UNITED STATES PATENT AND TRADEMARK OFFICE

| APPLICATION NO. | FILING DATE | FIRST NAMED INVENTOR | ATTORNEY DOCKET NO. | CONFIRMATION NO. |
|-----------------|-------------|----------------------|---------------------|------------------|
| 10/595,133 | 03/02/2006 | Per Anders Stenberg | P18463-US1 | 3249 |

| Office Action Summary | Application No. 10/595,133 | Applicant(s) STENBERG ET AL. | |

DETAILED ACTION

FIG. 4

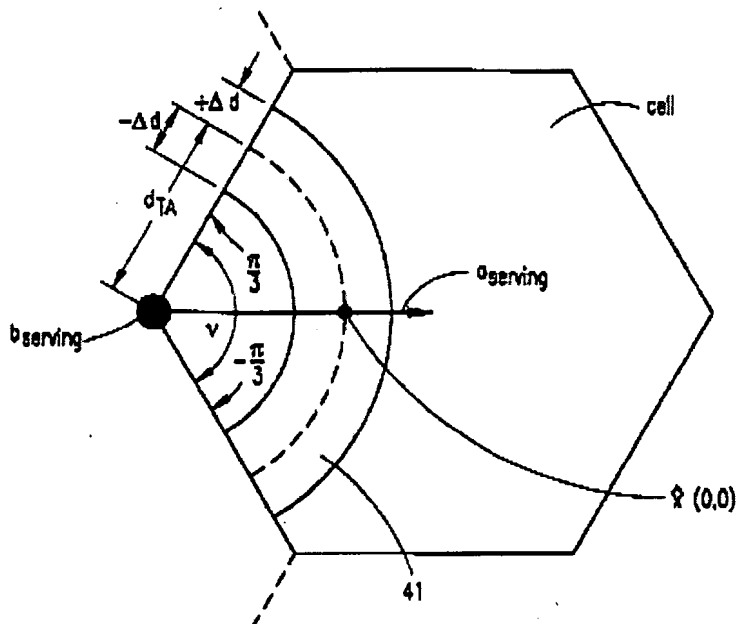
Regarding claims 1, 10, Larsson discloses the distance of a mobile transmitter to a site is determined by the propagation delay time/parameter (column 3, lines 34-42) and direction from the transmitter to the receiver (see Fig. 4 below).

FIG. 2

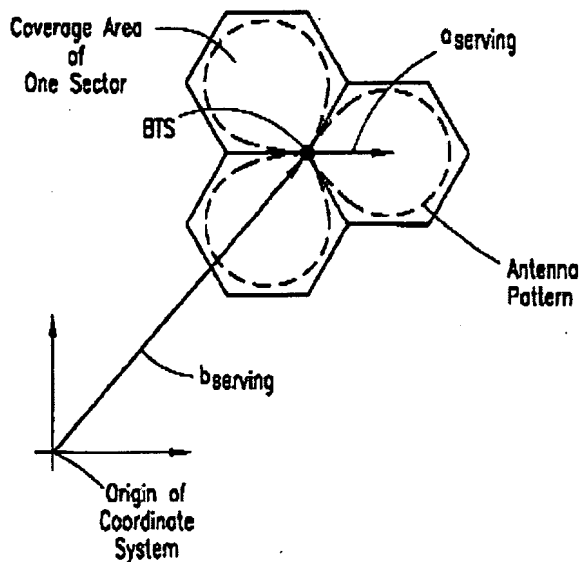
Regarding claims 2, 11, Larsson discloses the distance determination is based on at least one of the immediate neighbors of the cell where the transmitter is served (see FIG. 2 below).

FIG. 15

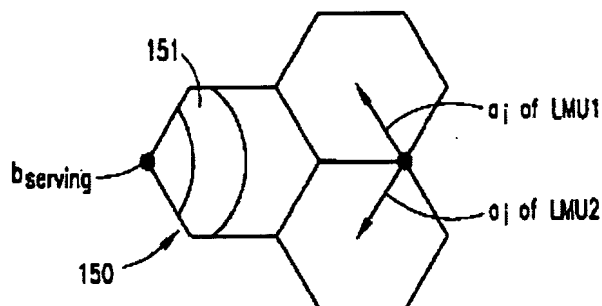
Regarding claims 3, 12, Larsson discloses the distance determination is based on a linear scale of or dB-scale difference (S/N ratio, see Fig. 15 below) (column 9, lines 16-28).

Fig. 8

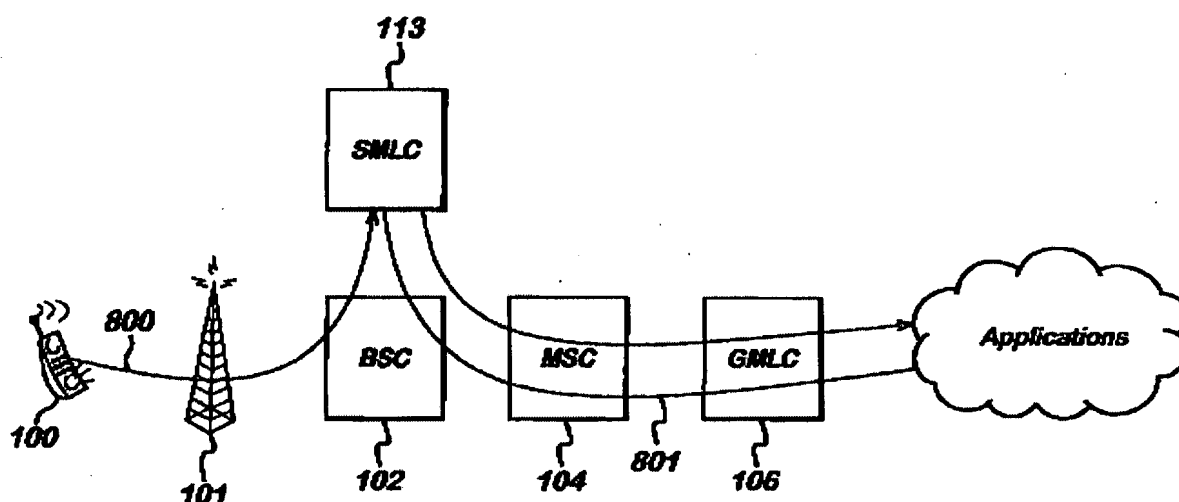
Regarding claims 6-9, 15-18, Larsson discloses the position determination based on average but fails to disclose the average is formed in a network control element (claims 6,15) or standardized interface (A-bis, lub) (claims 7, 16) or BSC (claims 8, 17) or RNC (claims 9, 18). However, Mannoja teaches the use of network control element

(SMLC, BSC, see Fig. 8 below) and RNC (for column 3, lines 9-25)

controlling/calculating the position of mobile. It would have been obvious to modify Larsson with Mannoja by incorporating SMLC, (A-bis, lub), BSC and RNC into the location service in order to satisfy GSM or UMTS system requirements.
